Access Compliance Report

Public Rights-of-Way

(Curb Ramps)

Intersection ID: 16976	Main Street: EDGE_LAKE_DR	Cross Street: WATER_RIDGE_PY	Location: W
ADA ID: A06407CC7F8B	Ramp Type: PerpDiag	Initial Pass/Fail: Fail	Overall Compliance: No
			Severity Score: 13.75

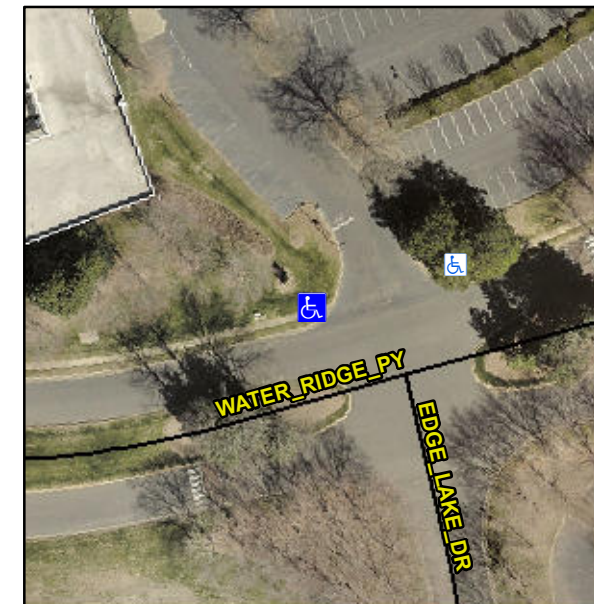
Not Found, R304.2.2, R304.5.3

Compliance	Description	Data	Compliance	Description	Data
N/A	Ramp Length (in)	35.0	No	Ramp Slope (%)	9.1
Yes	Ramp Width (in)	62.0	No	Ramp XSlope (%)	2.6
N/A	Flare Type LT	N/A	N/A	Flare Type RT	N/A
N/A	Flare Slope LT (%)	N/A	N/A	Flare Slope RT (%)	N/A
N/A	Flare Traversable LT?	N/A	N/A	Flare Traversable RT?	N/A
N/A	Landing Length (in)	N/A	N/A	DWS Provided?	N/A
N/A	Landing Width (in)	N/A	N/A	DWS Contrast?	N/A
N/A	Landing Slope (%)	N/A	N/A	DWS Length (in)	N/A
N/A	Landing X Slope (%)	N/A	N/A	DWS Full Width?	N/A
N/A	Landing Curb? (Y/N)	N/A	N/A	DWS Offset (in)	N/A
N/A	Shared Landing?	N/A			
N/A	Gutter Ponding?	N/A	N/A	Gutter Slope (%)	N/A
N/A	Gutter Lip Ht (in)	N/A	N/A	Gutter X Slope (%)	N/A
N/A	Painted X Walk1?	No	N/A	Painted X Walk2?	No
	X Walk 1 Direction	To S		X Walk 2 Direction	To E
N/A	X Walk 1 Width (in)	N/A	N/A	X Walk 2 Width (in)	N/A
	X Walk 1 Slope (%)	3.9		X Walk 2 Slope (%)	5.7
	X Walk 1 X Slope (%)	5.6		X Walk 2 X Slope (%)	2.7

Remove & Replace Curb Ramp With Two New Directional Ramps or Equivalent.
